**Process Sheet**

Customer Job Number : CU-DAR001 Dart Helicopters Services

: STEP BRACKET

D3729-1 STEP BRACKET

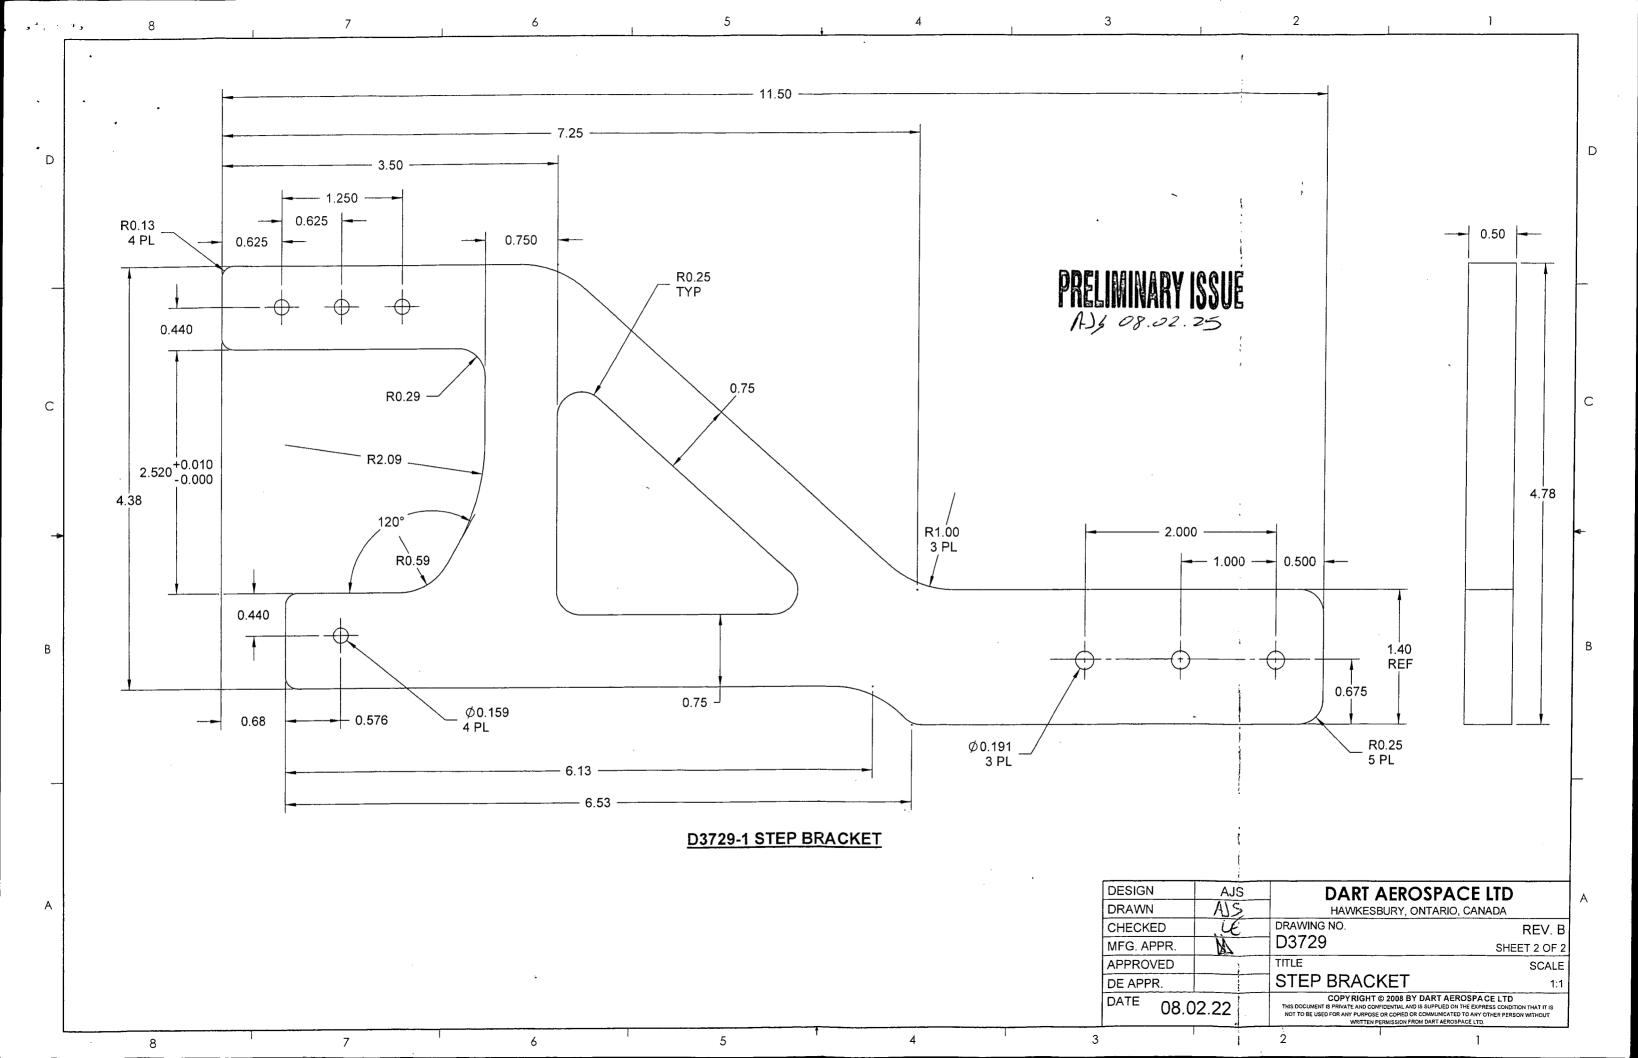
SHEET 2 ZONE 8C, 2.520 DIM WAS 2.51 & TOLERANCE HAS BEEN UPDATED. ZONE 7B & 7C, Ø0.159 HOLES ADDED.

**D3729-1 STEP BRACKET**

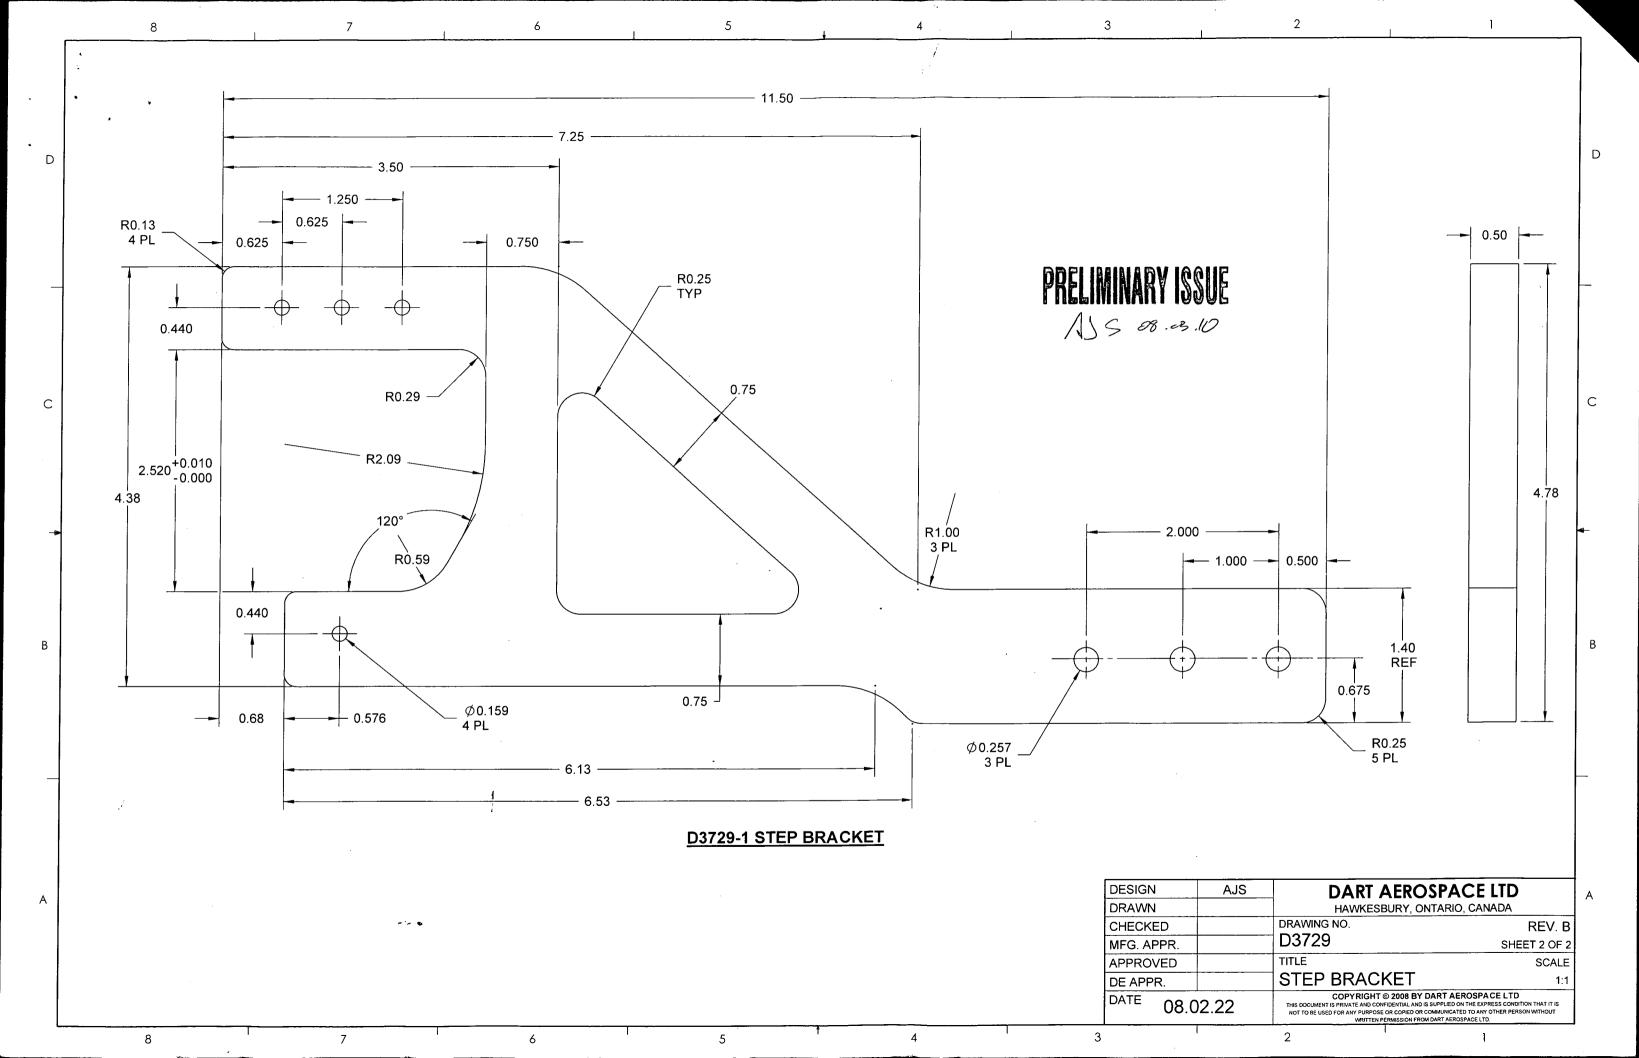
SHEET 2 ZONE 4B  $\phi$ 0.257 HOLE WAS  $\phi$ 0:191, 8C 2.520 DIM WAS 2.51 & TOLERANCE HAS BEEN UPDATED. ZONE 7B & 7C  $\phi$ 0.159 HOLES ADDED. AJS 08.02.22 **NEW ISSUE** AJS 08.02.04 REV. DESCRIPTION DATE **DESIGN DART AEROSPACE LTD** AJS DRAWN HAWKESBURY, ONTARIO, CANADA DRAWING NO. CHECKED REV. B D3729 MFG. APPR. SHEET 1 OF 2 APPROVED TITLE **SCALE** STEP BRACKET DE APPR. COPYRIGHT © 2008 BY DART AEROSPACE LTD
